Getting Stuck in UPDATE in the 1000BASE-T PHY Control State Machine

Presenter: James A. McIntosh
Vitesse Semiconductor Corp.

Figure 40-15b—PHY Control state diagram, part b (optional)

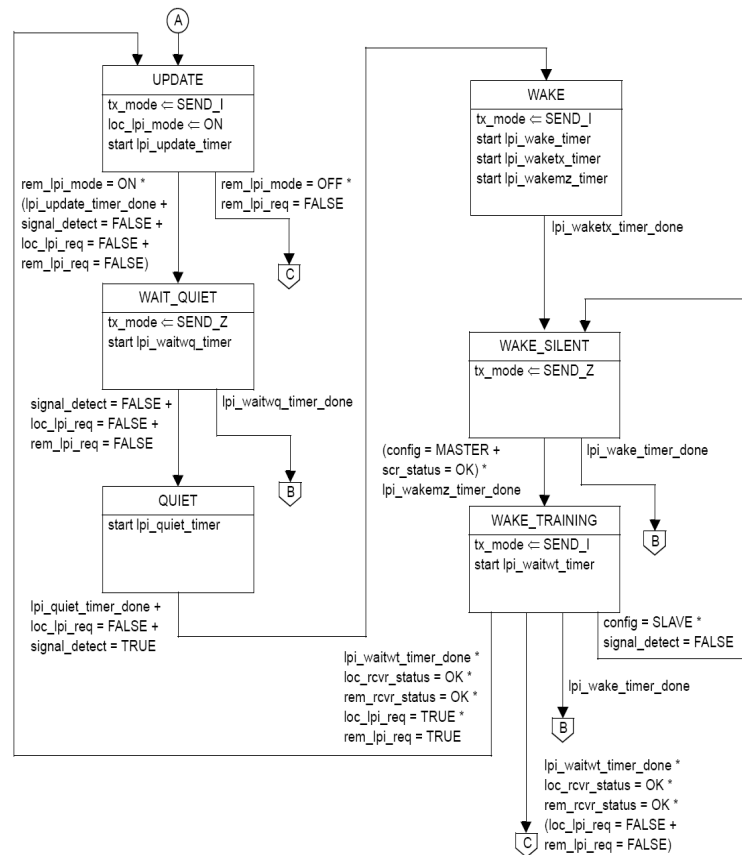
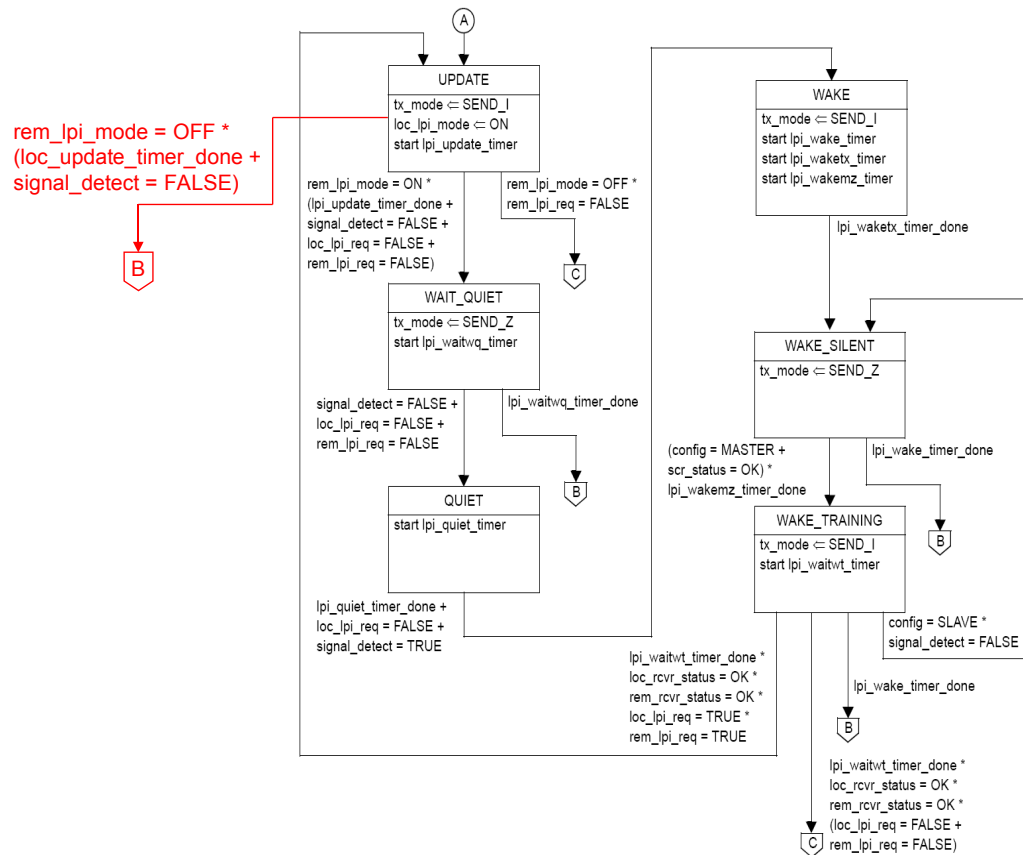
- We have discovered two corner cases while `rem_lpi_mode=OFF` that could leave us stuck in UPDATE.
 - `signal_detect=FALSE`
 - `lpi_update_timer_done`

- What happens when we are in the UPDATE state, rem_lpi_mode=OFF, and we observe signal_detect=FALSE?
 - This will not happen *normally*. In normal cases, at some point the link partner will transition to UPDATE and we will observe rem_lpi_mode=ON before it can transition to WAIT_QUIET (thus, tx_mode<=SEND_Z and we observe signal_detect=FALSE).
- What if the cable is unplugged at just the wrong time?
 - If, for example, the cable is unplugged and we observe signal_detect=FALSE before we observe rem_lpi_mode=ON, we will be stuck in the UPDATE state *forever*.
- Perhaps we should add a transition (to SLAVE SILENT) if rem_lpi_mode=OFF & signal_detect=FALSE to handle this error condition.

- What happens when we are in the UPDATE state, rem_lpi_mode=OFF, and the lpi_update_timer expires?
 - If rem_lpi_mode never goes to ON, we *should* see rem_lpi_req go to FALSE before the lpi_update_timer expires.
 - Otherwise, the remote link partner *should* see our lpi_req and go to UPDATE, therefore setting rem_lpi_mode to ON.
- However, if the lpi_update_timer expires while rem_lpi_mode=OFF, there is probably a problem with the link partner and we could, again, be stuck in the UPDATE state.
- Perhaps we should add a transition (to SLAVE SILENT) if rem_lpi_mode=OFF & lpi_update_timer_done to handle this error condition.

Proposed changes to Figure 40-15b
